CALIBRATION BLOCKS
FOR
INSERVICE EXAMINATION

INDIAN POINT UNIT NO.3 NUCLEAR POWER PLANT
P.O.BOX 215
BUCHANAN,NEW YORK 10511

NEW YORK POWER AUTHORITY
123 MAIN STREET
WHITE PLAINS,NEW YORK 10601

WESTINGHOUSE ELECTRIC CORPORATION
NUCLEAR SERVICE INTEGRATION DIVISION
INSPECTION SERVICES
P.O.BOX 355
PITTSBURGH,PANNSYLVANIA 15230

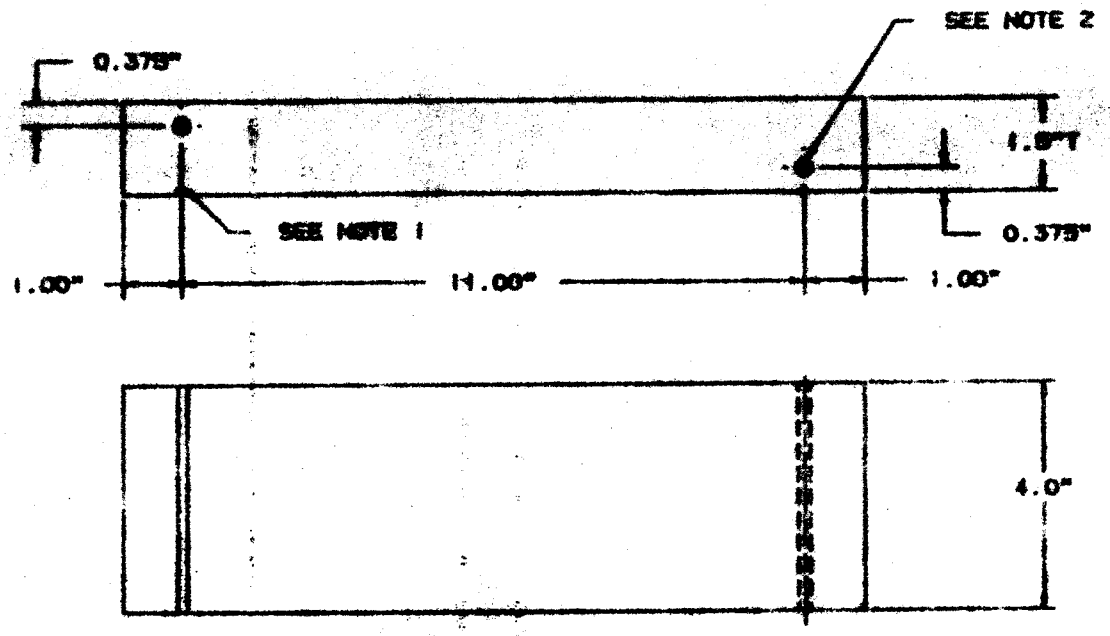
Calibration block to meet Section V 1983 Edition through Summer 1983 Addenda would be to design calibration block to requirements of "T-546 Welds in Wrought and Cast Ferritic Product Forms, Excluding Pipe and Figure T-546.1".

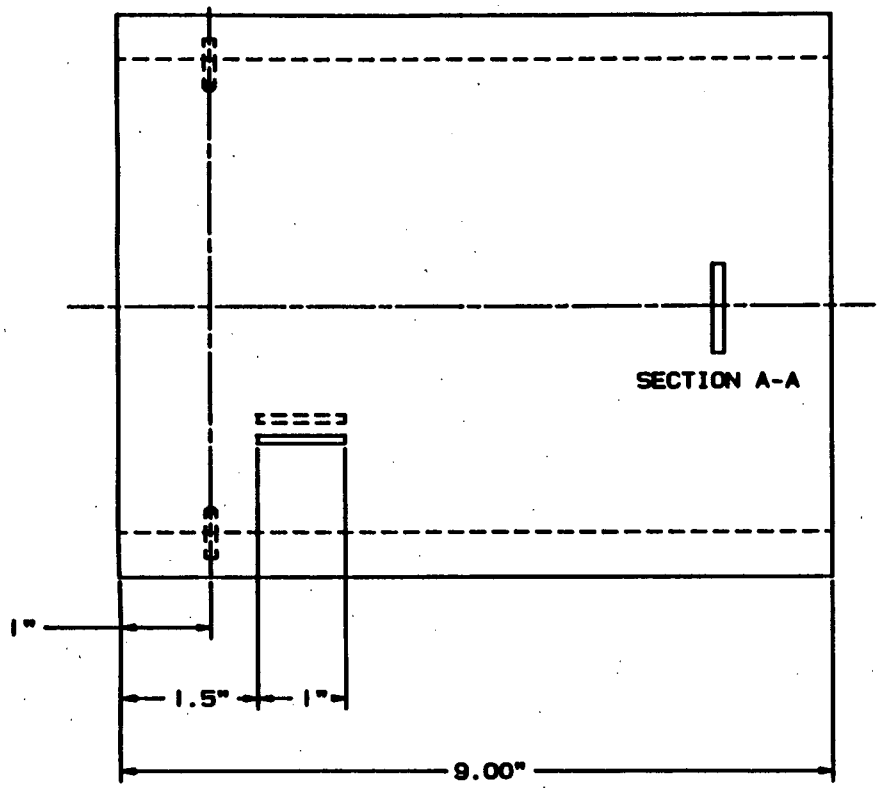
Calibration block to meet the requirements of ASME Boiler and Pressure Vessel Code Section V and XI 1983 Edition through Summer 1983 Addenda would require a new block with diameter of 28" and a thickness of 1.04" designed to Figure T-547.1. P-Number Groupings for Materials A516 Grade 70 Carbon Steel and A155 KC 70 Class 1 Carbon Steel are equivalent.

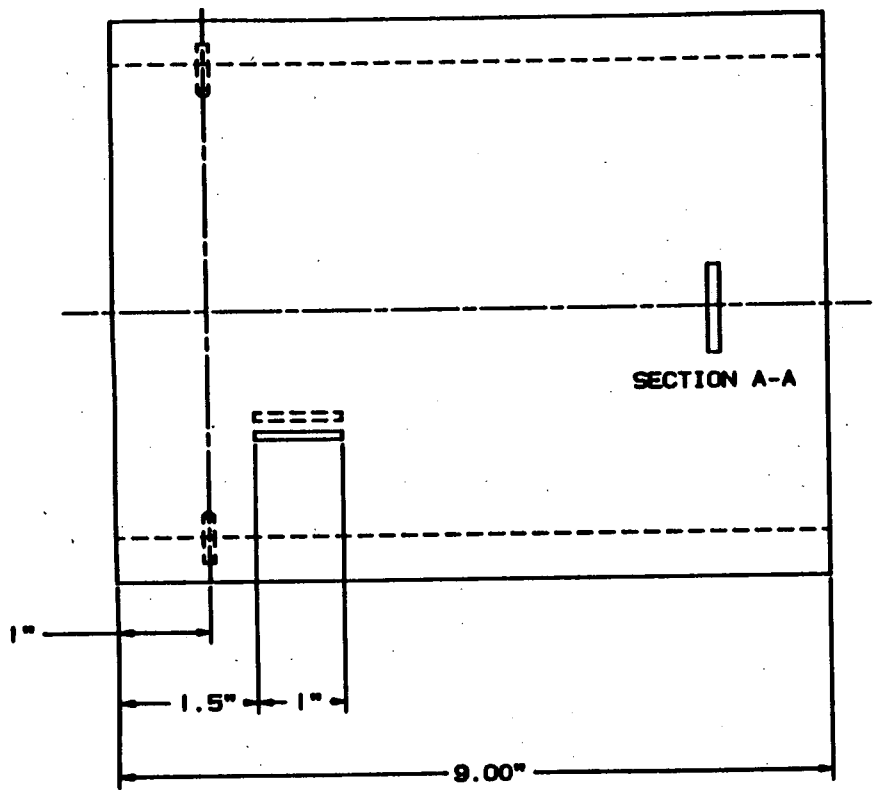
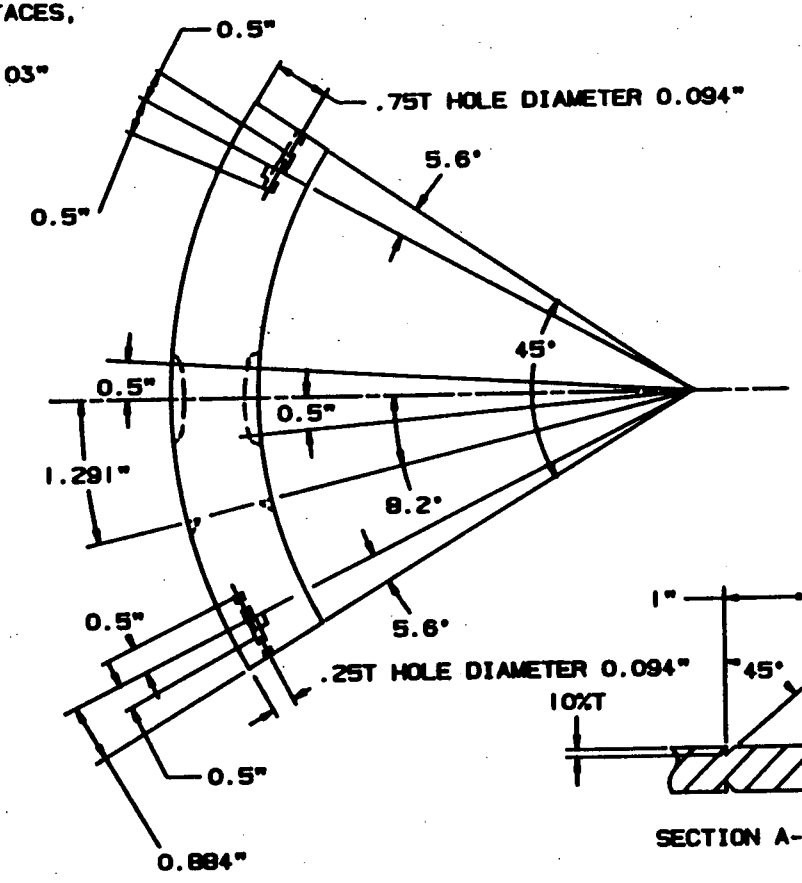
Calibration block follows the design and requirements for Section V and Section XI of the 1983 Edition through Summer 1983 Addenda except for arc length of 52° instead of 45° as required by Figure T-547.1 and notch depth to 0.104T - 0.009T squared with tolerances of +10%-20% as required by Table III-3430-1. P-Number Groupings for Materials A106 Grade B Carbon Steel and A106 Grade C Carbon Steel are equivalent.

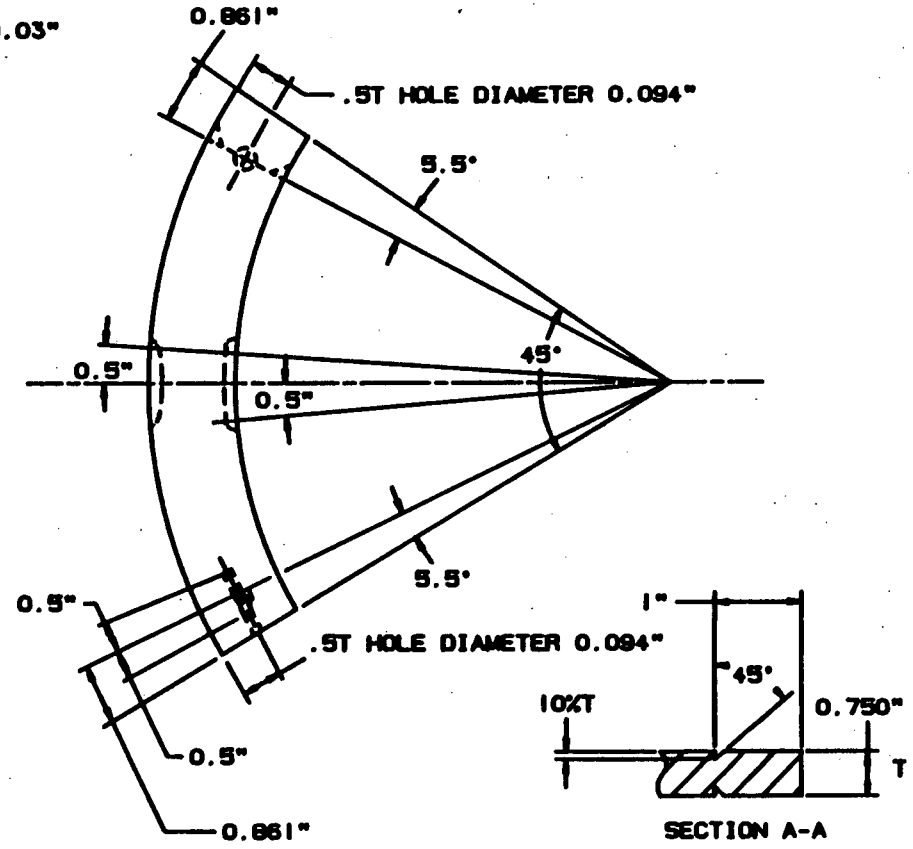
Calibration block follows the design and requirements for Section V and Section XI of the 1983 Edition through Summer 1983 Addenda except for arc length of 52° instead of 45° as required by Figure T-547.1 and notch depth to 0.104T - 0.009T squared with tolerances of +10%-20% as required by Table III-3430-1. P-Number Groupings for Materials A106 Grade B Carbon Steel and A106 Grade C Carbon Steel are equivalent.

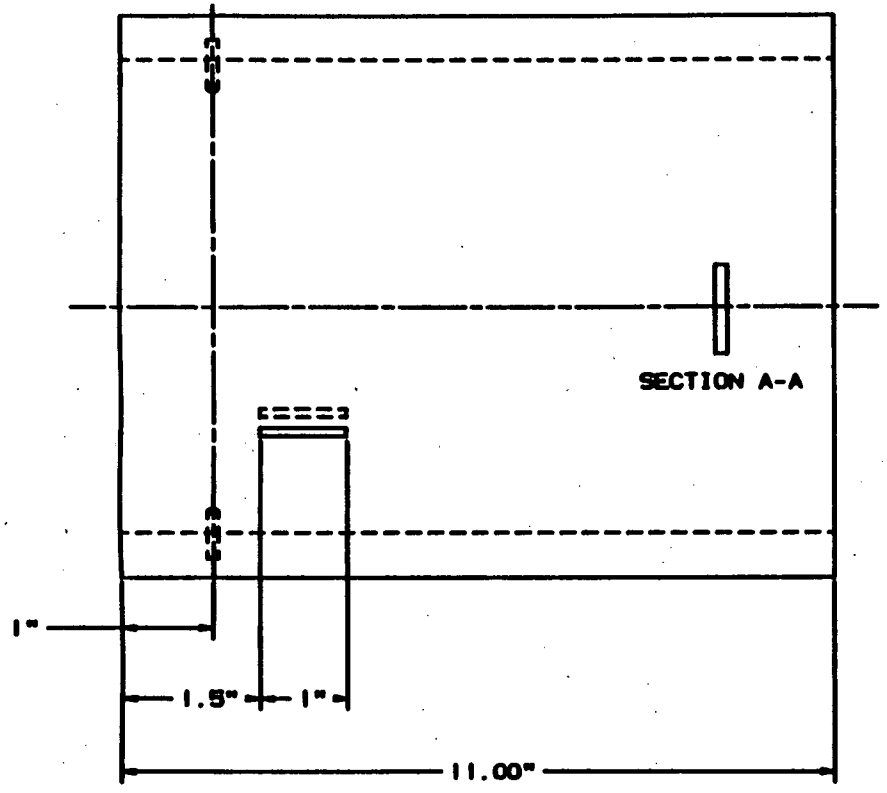
Calibration block design follows the guidelines of Section V and Section XI 1983 Edition through Summer 1983 Addenda for Austenitic Piping. Modifications of this design to meet the requirements of Section V and XI - 1983 Edition through Summer 1983 Addenda for calibration blocks for "ferritic piping and design T-547.1" would be to increase arc length to 70° and locate longitudinal notches a minimum of 1.25" from edge of block and as required by Table III-3430-1 notch depth to 0.104T - 0.009T squared with tolerance of +10%-20%.

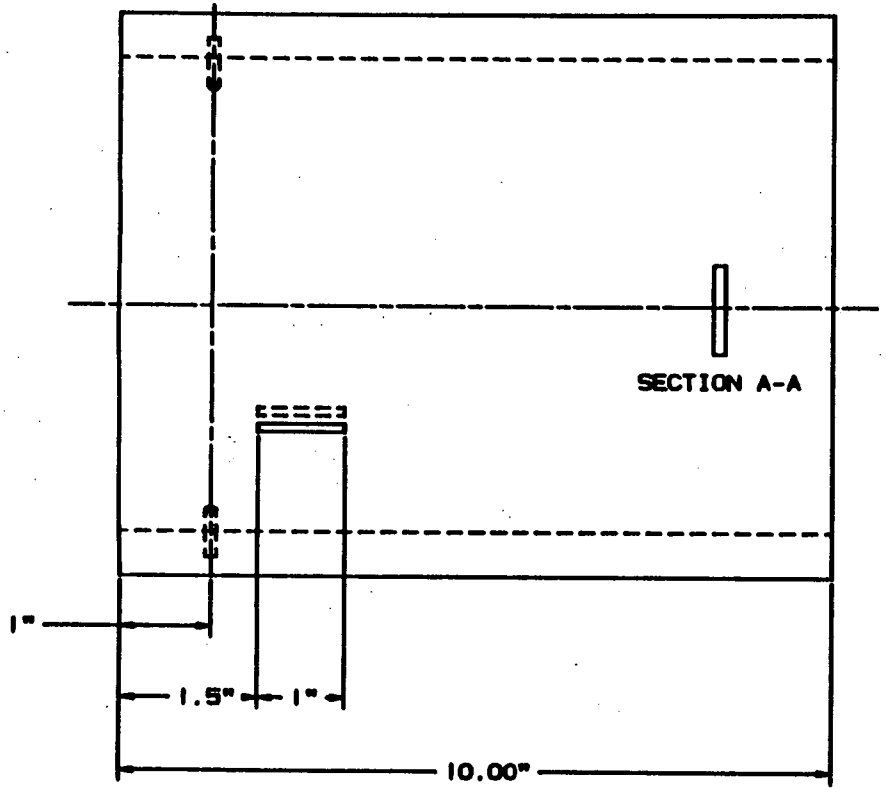
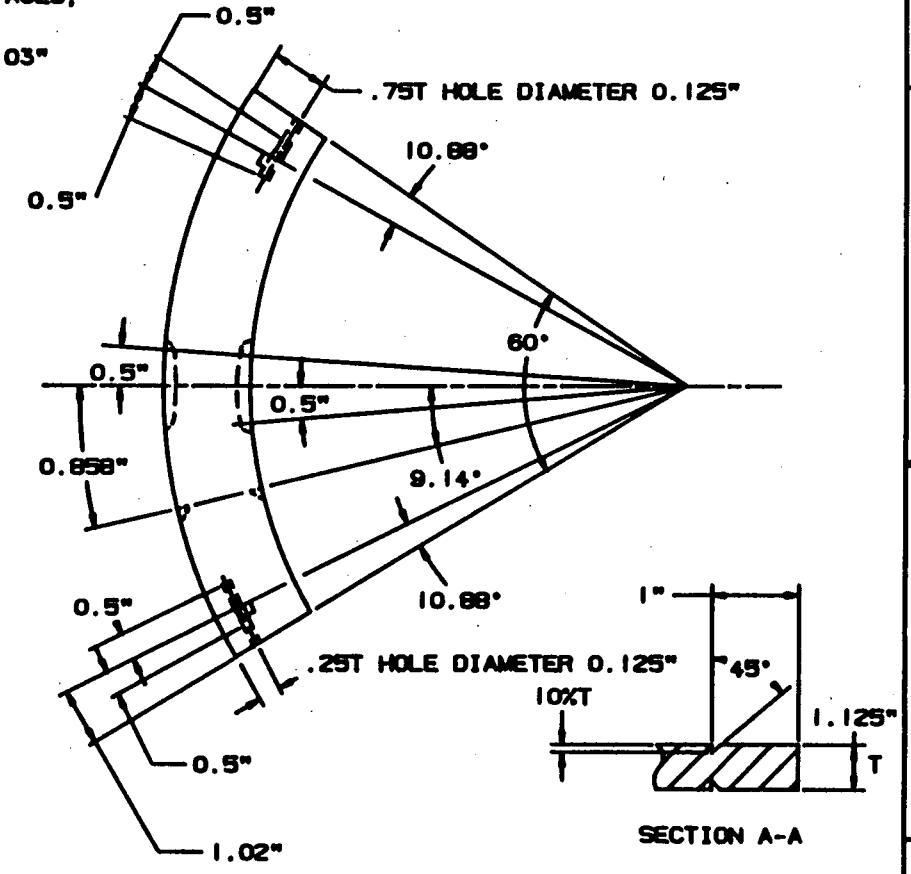
Calibration block design follows the guidelines of Section V and Section XI 1983 Edition through Summer 1983 for Austenitic Piping. At this time there is no existing Class 1 or Class 2 10" SCH 160 Stainless Steel Piping and this calibration block is not required. Modifications of this design to meet the requirements of Section V and XI - 1983 Edition through Summer 1983 Addenda for calibration blocks for "ferritic piping and design T-547.1" would be to increase arc length to 95° and locate axial notches 1.125" minimum from edge of block and as required by Table III-3430-1 notch depth to 0.104T - 0.009T squared with tolerance of +10%-20%.

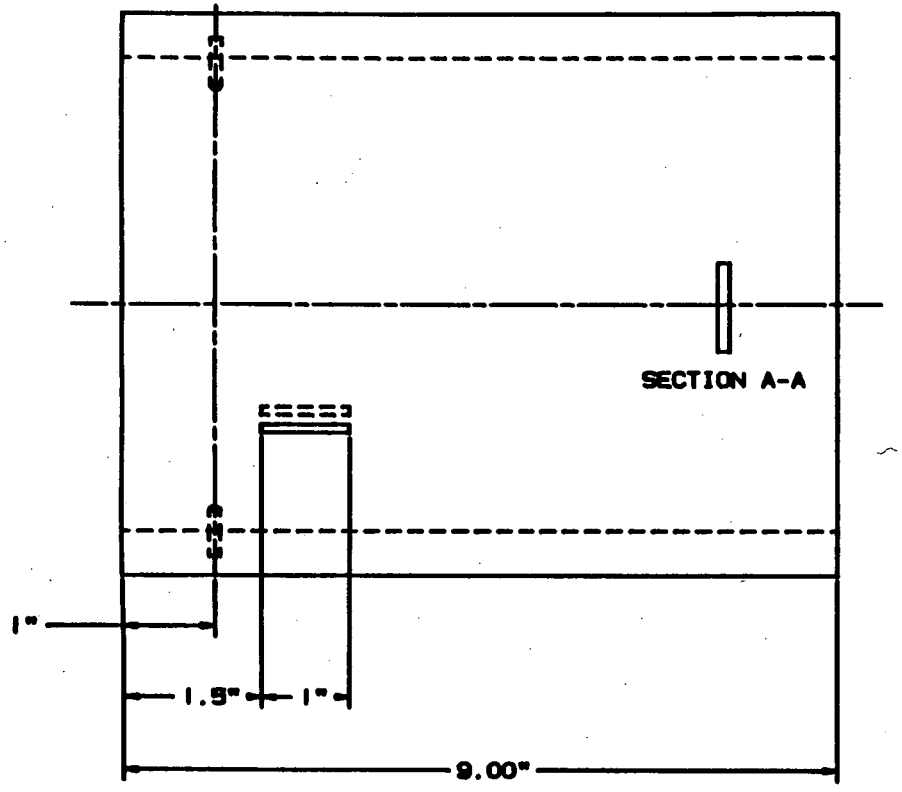
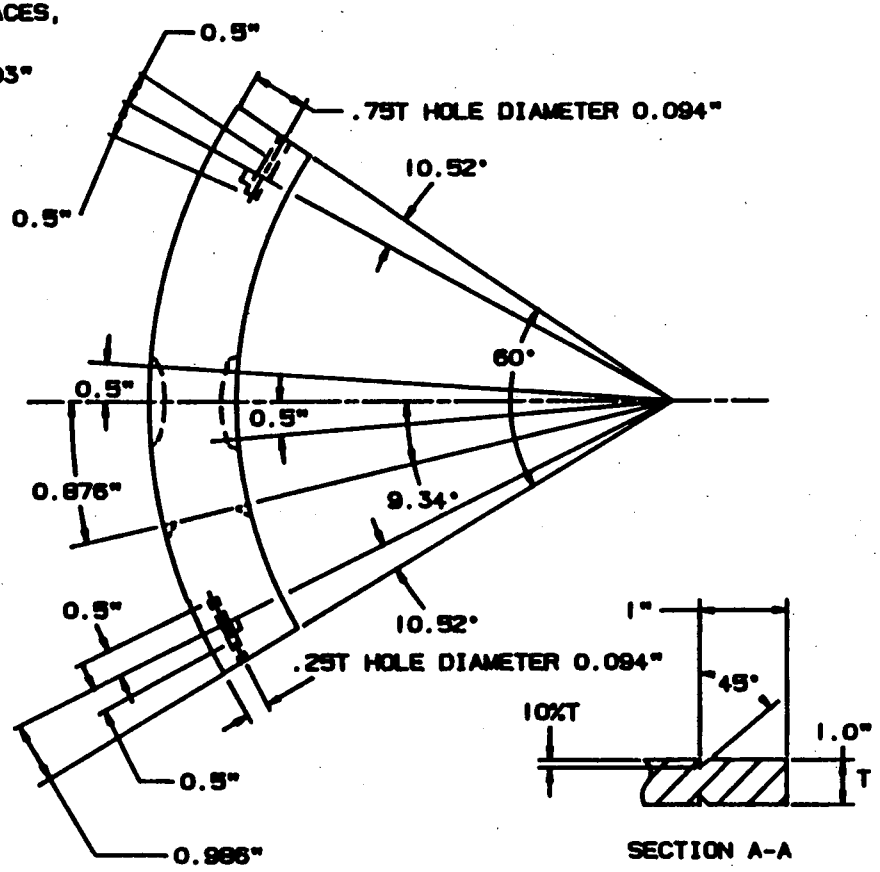
Calibration block design follows the guidelines of Section V and Section XI - 1983 Edition through Summer 1983 Addenda for Austenitic Piping. Modifications of this design to meet the requirements of Section V and Section XI - 1983 Edition through Summer 1983 Addenda for calibration blocks for "ferritic piping and design T-547.1" would be to increase arc length to 95° and as required by Table III-3430-1 notch depth to 0.104T - 0.009T squared with tolerance of +10%-20%. P-Number Groupings for Materials A312 TP304 Stainless Steel and A376 TP316 Stainless Steel are equivalent.

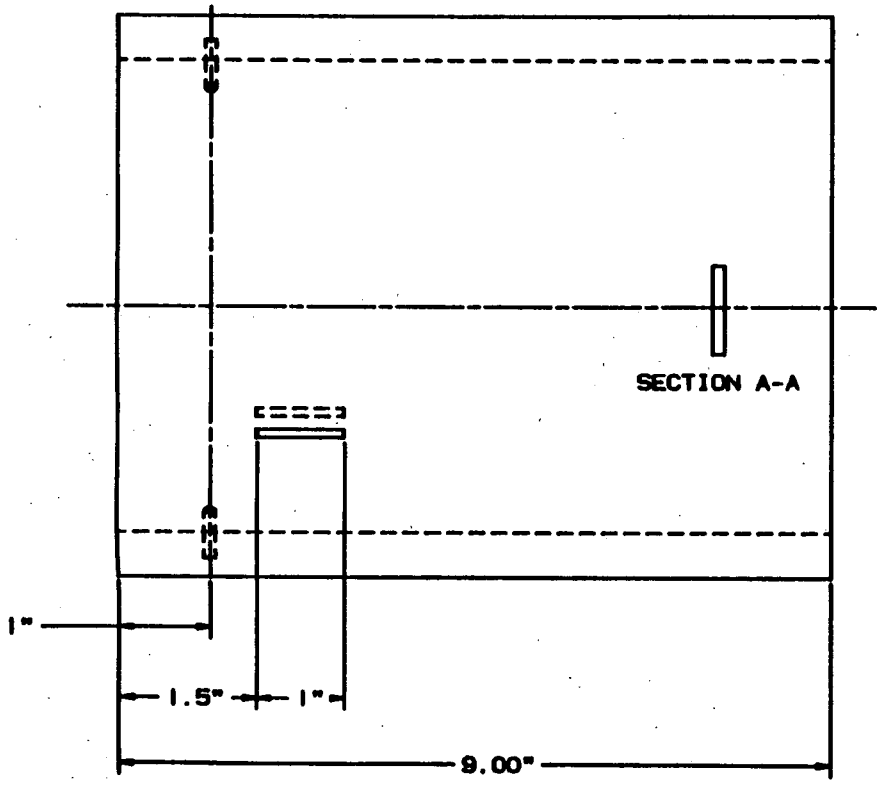
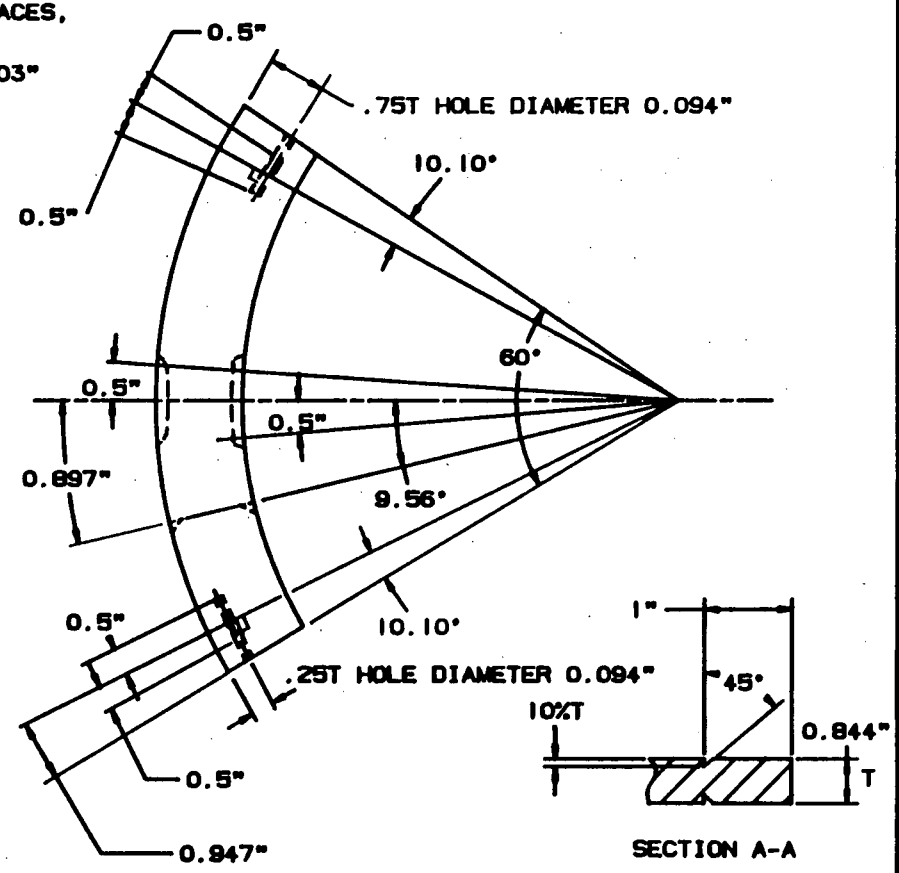
Calibration block design follows the guidelines of Section V and Section XI - 1983 Edition through Summer 1983 Addenda for Austenitic Piping. Modifications of this design to meet the requirements of Section V and Section XI - 1983 Edition through Summer 1983 Addenda for calibration blocks for "ferritic piping and design T-547.1" would be to increase arc length to 95° and as required by Table III-3430-1 notch depth to 0.104T - 0.009T squared with tolerance of +10%-20%.

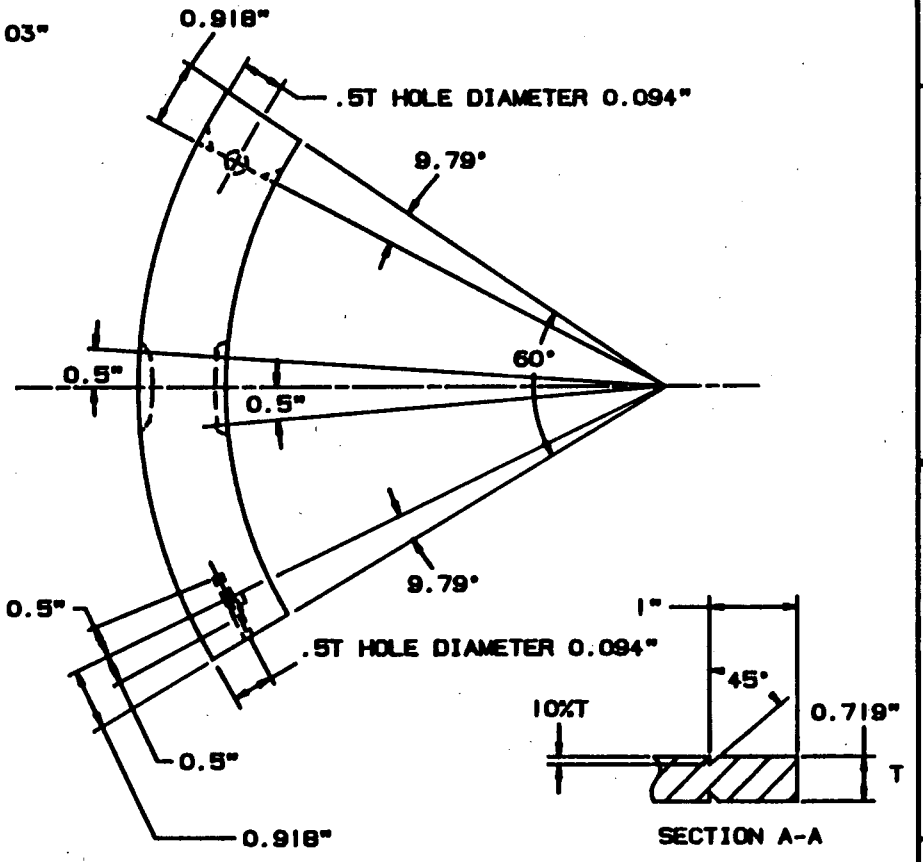
Calibration block follows the design and requirements of Section V and Section XI - 1983 Edition through Summer 1983 Addenda except for acr length of 95° instead of 60° as required by Figure T-547.1 and notch depth to 0.104T - 0.009T squared with tolerance of +10%-20% as required by Table III-3430-1. At this time there is no existing Class 2, 10" SCH 100 Carbon Steel Piping and this calibration block is not required.
